Re: M/035/002 – Bingham Canyon Mine
       May 12, 2008 Order Vacating NOV #N2007-58-01
       Waste Rock Stability Study and Results of DAN-W
       Submittal of Revised Documents

Pursuant to the Division's 2009-10-19 letter, KUC is herewith submitting the
following revised documents (in track change where applicable) in response
to Task 13-16, Comments 3-35 of that letter:
o FILE01AKUCCommentResponseTableUDOGM2009-10-19
o FILE02Rev2009-10WasteRockDumpsSummaryReport
o FILE02A-Rev2009-10WasteRockDumpsSummaryReportFigureA-3
   (included in FILE02)
o FILE03-Rev2009-10AppendixA-FoundationConditions(South)
o FILE04-Rev2009-10AppendixB-WasteRockMaterialProperties
o FILE05-Rev2009-10AppendixC-StabilitySouthernWasteRock
o FILE06-Rev2009-10AppendixD-
   ConstructionSouthWasteRockDumpsOverTime

This report entitled *Kennecott Utah Copper South Waste Rock Dumps Summary Report October 2009* has been prepared to fulfil the requirement identified at Page 3, Item c. of the Order Vacating Notice of Violation N2007-58-01 for an off site excursion that occurred in July 2007. Specifically, Item c. states: "Undertake additional modelling and prepare a slope stability study to supplement the existing

Figure 3 - Shear strength of rock fill based on Leps chart correlating rock fill shear strength to confining stress

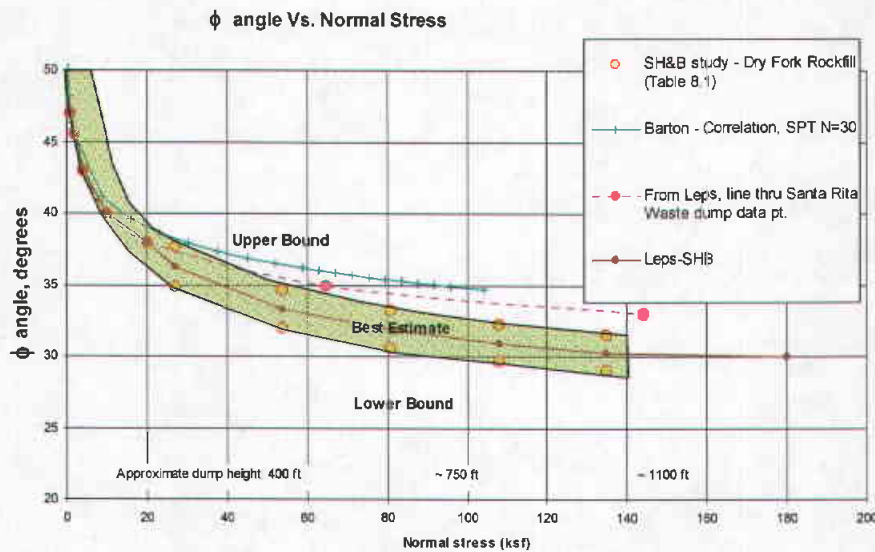
15	App A Page 26 Bullet 6	As written "figure 2". Which figure 2?	Corrected to Figure 3, this document. This figure is also found in Appendix B.
16	App A Page 27 Table 8	No shear strength parameters are given in table 8; please provide	Table 8 here and elsewhere was modified to include the actual shear strength parameters used, along with a rational of why the values were selected.
17	App A Page 28 Table 9	Is the only geotechnical stability analysis variable not controlled by KUC in the phreatic surfaces? Is no additional loading of the dumps planned? If this is correct, please make this statement in the report and discuss the impact in the text.	If any modifications are made to the current dumps, such as additional loading, such loading geometries will be assessed. KUCC has made and will continue to make efforts to control infiltration into the dumps, and will strive to keep infiltration at or below current levels.

Figure 4 - Extent of dumping at approximately 10 year increments in time.

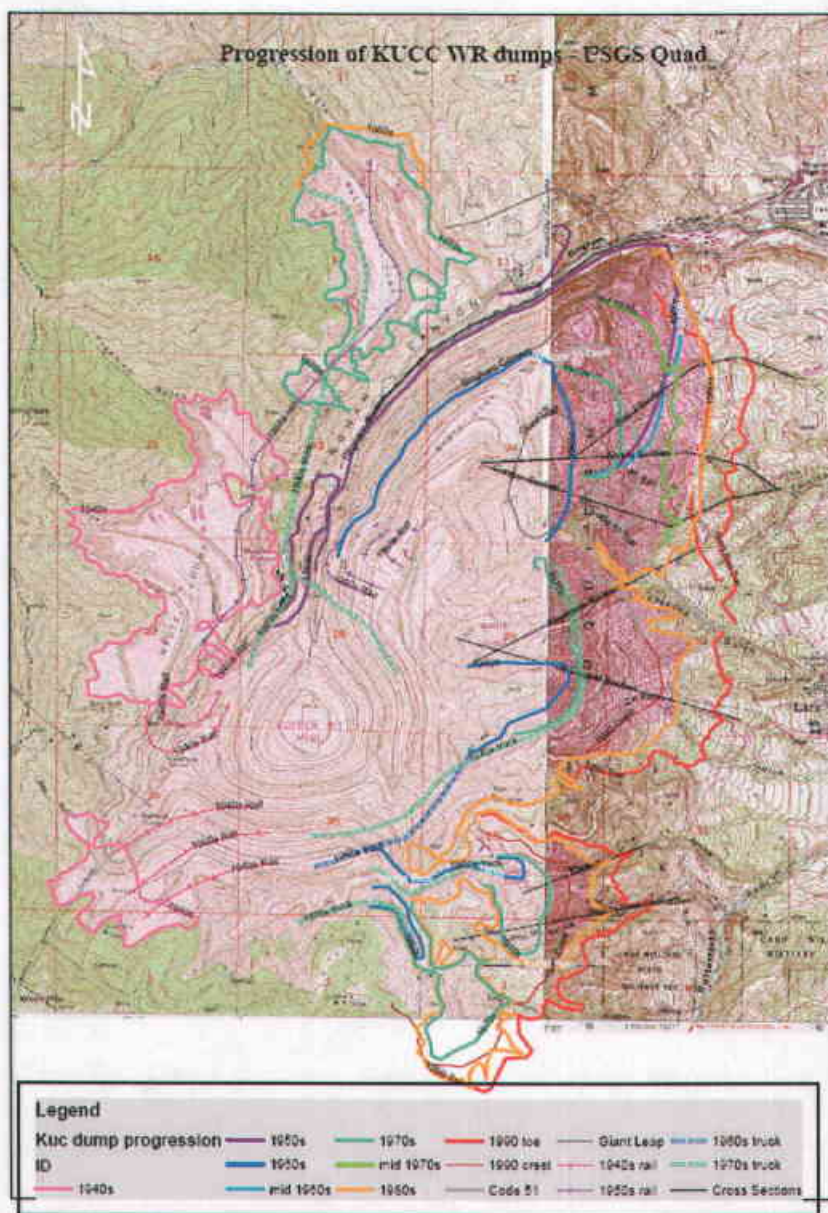
8	App A Page 16 Para 2	Dump map is Figure 4 and not figure 3 as written – apparent typo.	Correct reference has been provided.
9	App A Page 18 Para 2	DOGM does not believe that testing to a depth of 16.5 feet is indicative of the surface water infiltration rate throughout the entire column of all the south waste dumps area.	KUCC agrees with the comment on depths and number of investigations. However, the point was that these shallow investigations revealed a surface "base coarse layer." The base coarse was placed across the entire dump surface by mine operations. Otherwise we agree that investigation of just the upper dump surface is not indicative of the entire dump. A discussion has been added describing the general permeability trend versus depth.

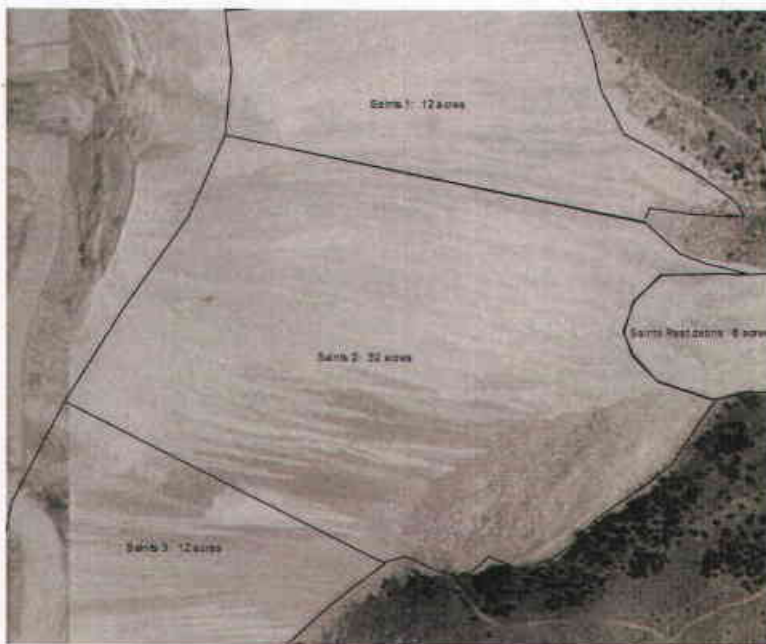
27	App F Page 31	Figure A-16 indicates a perched table represented by rilling on the south side of Saints 2 approximately 50% of the distance from the toe to the crest. Is there an explanation for the rilling? Is the area a future problem?	Table 2 has been corrected to reflect the correct name of the dump that failed due to leaching in 1979. The rilling appears to be associated with the backfill location of previous 1979 failure. The rilling is most likely due to head cutting, but could be manifestation of perched water table. We do not believe this is a problem because this area has been stable since being backfilled in 1979. Leaching of the South dumps will not be attempted again due to the high calcium content.
28	App F Page 42	It is unclear why figure B-26 was addressed in appendix F and not in Appendix G. This figure is also shown as figure 2 on page 10 of the report.	Figure B-26 was originally in a separate memo. However, the photograph does represent slippage along an infinite slope condition and is now cross referenced. The discussion of the infinite slope condition is "beefed up" with a cross reference to this figure in Appendix G.
